**Subject** ▶ Replacement of Torx Socket Head Bolt and Addition of Spring Washer 5

**For Models** ▶ JR140D, JR180D, JR3000VT, JR3030T

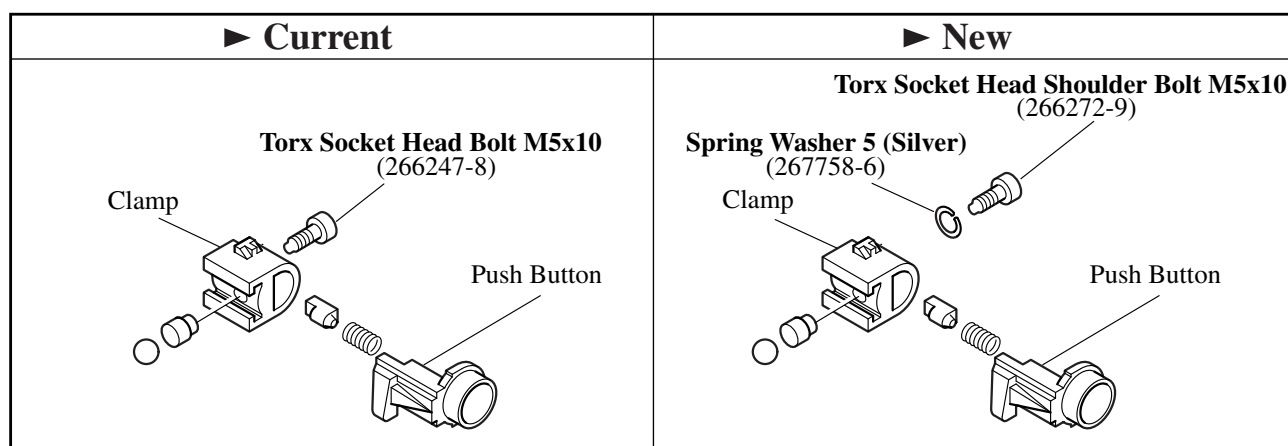
1. Torx Socket Head Bolt M5x10 has been replaced by Torx Socket Head Shoulder Bolt M5x10.
2. Spring Washer 5 has been added.
3. Fastening torque of Torx Socket Head Bolt/Torx Socket Head Shoulder Bolt has been changed from 4.0 N.m to 10.0 N.m. Use the following repairing tools to obtain the proper fastening torque.

IR219 Torque Wrench

IR220 Ratchet Head for Torque Wrench

IR222 Socket Adapter

IR290 Torx Bit VT27

134873-0 Bit Adapter
